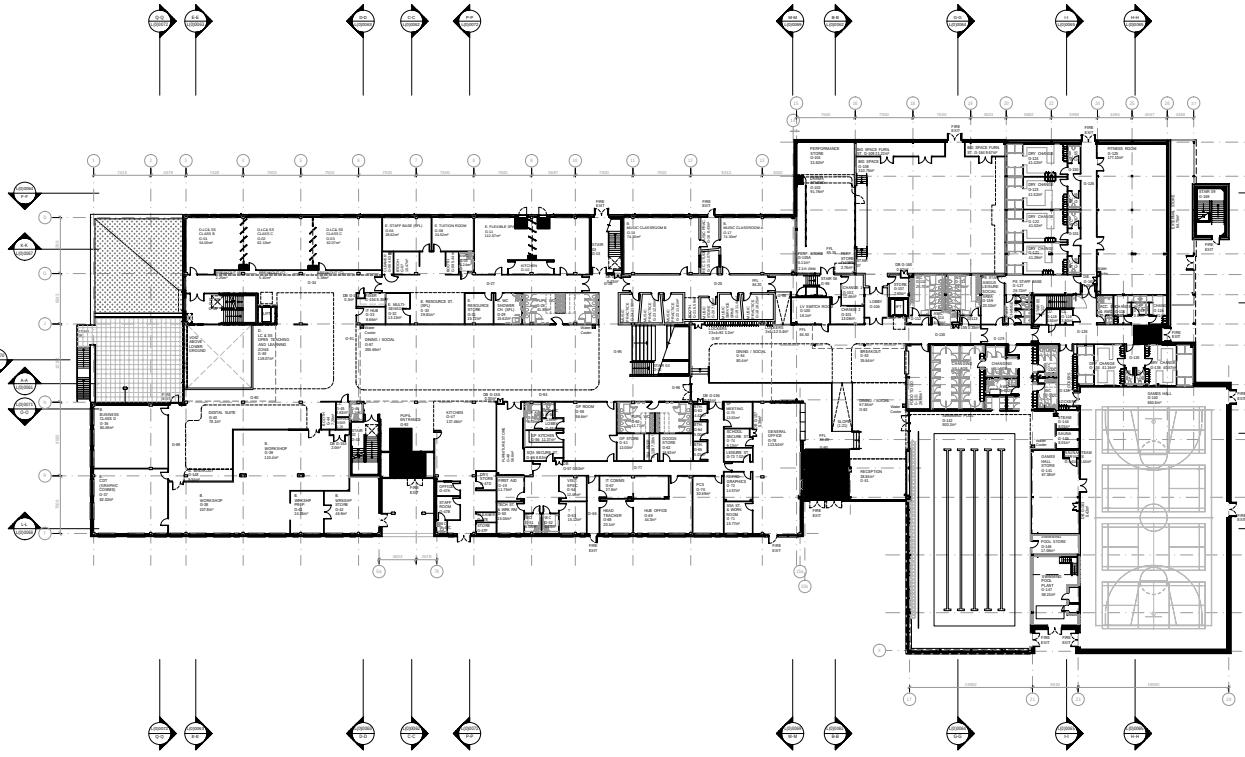
H	STAIR 05 AMENDED TO RESOLVE STRUCTURAL CLASH; LOCKERS AMENDED & REPOSITIONED FOLLOWING CONFIRMATION OF SIZE FROM FF&E SUPPLIER; SAUNA & STEAM ROOM DOORS OMITTED DUE TO SUPPLY BY SUB-CONTRACTOR; SWIMMING POOL PLANT ROOM INCREASED IN SIZE; SWIMMING POOL STORE REDUCED IN SIZE; STEAM & SAUNA SERVICES CUPBOARD ADDED; GAMES HALL STORE REDUCED IN SIZE; ALL CLOSING INSTRUCTION FROM CONTRACTOR'S STRUCTURAL ENGINEER UPDATED TO ACCORD WITH STRUCTURAL ENGINEER'S INFORMATION (GRID LINES 33, 6 & Q RELOCATED); COLUMN LAYOUT UPDATED TO ACCORD WITH STRUCTURAL ENGINEER'S LAYOUT.	23.09.14	AA	GJB
G	LC & SS OPEN TEACHING & LEARNING FLOOR AREA AMENDED TO ACCOTED WITH WALL FROM LOWER GROUND FLOOR (62-N); WALL BETWEEN EXTERNAL TERRACE & ROOF RELOCATED; EXTERNAL TERRACE (1-31/4) AREA REDUCED TO SUIT. PLANTERS ON TERRACES OMITTED.	04.08.14	AA/GJB	GJB
F	SLIDING FOLDING PARTITION SCHEDULE AMENDED TO AVOID CLASH WITH CONCRETE FRAME IN LC&SS CLASS (G-024/23); STATUS CHANGED TO CONSTRUCTION.	03.07.14	AA	GJB

E	WATER COOLERS ADDED DINING/SOCIAL (G-82 & G-97), SWIMMING POOL (G-143), PE CORRIDOR (G-128); WINDOWS RELOCATED IN LC&SS CLASS (G-01); EXTERNAL DOORS RELOCATED IN FLEXIBLE SPACE (G-13); CHANGE REQUEST NOTES OMITTED; BIG SPACE (G-108) SEATING OMITTED; G-100 CHANGED FROM LOCKERS TO LV SWITCH ROOM, LOCKERS REALLOCATED TO G-97 & AREA AMENDED TO MUSIC PRACTICE (G18), MUSIC SERVICE SPINE (G-19), MUSIC STORE (G-20); STAIRS @ DINING/SOCIAL (G-82 & G-96) RATIONALISED; CHANGING VILLAGE RESPLANNED - ROOM Nos G-133A,B,C,D ADDED; DRAMA STUDIO SLIDING PARTITION OMITTED;	05.05.14	AA	GJB
	DOUBLE DOORS ADDED TO CIRCULATION @ STAIR 04 (G-96); CRECHE, WC & CRECHE KITCHENSTORE REPLACED WITH GP WC (G-53), LOBBY (G-59A), KITCHEN (G-56), GP AWC (G-58), GP ROOM (G-59) AMENDED TO SUIT; TEA PREP (G-129) ADDED & SQA SECURE STORE (G-66) RELOCATED TO SUIT; PE STAFF BASE (G-127), PE STAFFANGUS LEISURE (G-158), STAFF CHANGE (G-147), ACC CH & WC (G-125), CHANGE (G-115+116), WC (G-142) & FITNESS SUITE (G-125) EXTENDED; ALL FOLLOWING CLIENT FEEDBACK/INSTRUCTION.

D	ROOM NUMBERING AMENDED & UPDATED; EXTERNAL WALL CONSTRUCTION CONFIRMED & UPDATED; WINDOWS UPDATED; EXTERNAL WALL GRID LINES & CONCRETE COLUMNS RELOCATED TO SUIT EXTERNAL WALL CONSTRUCTION; CHANGE REQUEST NOTE OMITTED; G-100 CHANGED FROM LOCKERS TO LV SWITCH ROOM, LOCKERS RELOCATED TO G-97 & G-18, 19, 20 AREAS REDUCED TO SUIT; CHANGING VILLAGE (G-132, A-D) UPDATED FOLLOWING CLIENT/CONTRACTOR INSTRUCTION & CIRCULATION (G-133) AMENDED TO SUIT; DINING/SOCIAL (G-82) AREA REDUCED IN SIZE; RELOCATED TO ACCOMMODATE STAIR 05 (G-96); STAIR WIDTH REDUCED TO SUIT; GP ROOM LAYOUT AMENDED INCORPORATING ROOM Nos G-59, G-59A, G-56, G-58, G-59, G-66, G-139.	30.04.14	GJB	AA
C	FLEXIBLE SPACE (G-11) - SLIDING PARTITION & KITCHEN WALLS BUBBLED & CHANGE REQUEST NUMBER INDICATED; CHANGE REQUEST NOTE ADDED; PUPIL ENTRANCE SCREENS ALIGNED WITH EXTERNAL WALL ABOVE, ENTRANCE MATTING AMENDED TO SUIT; SWIMMING POOL RELOCATED TO ACCOMMODATE POOL SIZE SEATING, HANDRAIL ADDED.	20.02.14	GJB

B	ENTRANCE MATWELLS INDICATED; SB, WC/SHOWER G-29 - WC & SHOWER INDICATED; PUPIL WC G-38 & G-60 - WASH FOUNTAIN OMITTED & REPLACED WITH VANITY UNIT AS PER CLIENT INSTRUCTION; MUSIC PRACTICE & RECORDING STUDIO WALLS ANGLED AS PER ACOUSTIC CONSULTANTS ADVICE; WALLS & DOORS WITHIN KITCHEN AREA INDICATED AS PER SPECIALIST SUPPLIER'S LAYOUT; DOORS ADDED TO BOOTHS G-63, 64, 65 FOLLOWING CLIENT/CONTRACTOR INSTRUCTION; GENERAL OFFICE G-78 - RECEPTION DESK SIZE AMENDED; STAIRS BETWEEN G-96 & G-97 AMENDED; STAIR 04 - WALL LAYOUT AMENDED TO ALIGN WITH STRUCTURAL ENGINEER'S REQUIREMENTS; VAT CHANGING VILLAGE (G-132) AMENDED TO ACCOMMODATE LOCKERS RELOCATED TO G-124-126, 134 & 135; LOCKER Nos AMENDED & LAYOUT INDICATED TO PE STAFF BASE & ANGUS LEISURE SOCIAL AREA G-127; STAIR 04 INDICATED; NOTES AMENDED.	28.01.14	GJB	
A	ROOM NUMBERS ADDED; STRUCTURAL GRID UPDATED & STRUCTURE INDICATED; MINOR WALL AMENDMENTS TO SUIT STRUCTURE; SERVICE RISERS & DB'S INDICATED; INTERNAL WALLS UPDATED TO REFLECT ACOUSTICIAN'S REPORT; CHANGING LAYOUTS INDICATED TO G-116, 121-126, 134, 135; STAIRS FROM BIG SPACE & CIRCULATION TO DRAMA & SLOPES TO G-80 & 98 AMENDED TO SUIT LEVELS; EXTERNAL STORE REDUCED TO ACCORD WITH STRUCTURE; STAIR 02 (G-43) & AWC (G-46) AMENDED; EXIT DOOR FROM BIG SPACE REPOSITIONED; STAIR 04 MOVED ACCORDING TO THE BENEFIT OF FIRST FLOOR CORRIDOR F-36; FOLLOWING CLIENT INSTRUCTION, THE FOLLOWING AREAS AMENDED - ADN, ADMIN, MUSIC, STEAM/SAUNA, DEPARTMENT COLOURS OMITTED.	08.11.13	SM/GJB	GJB
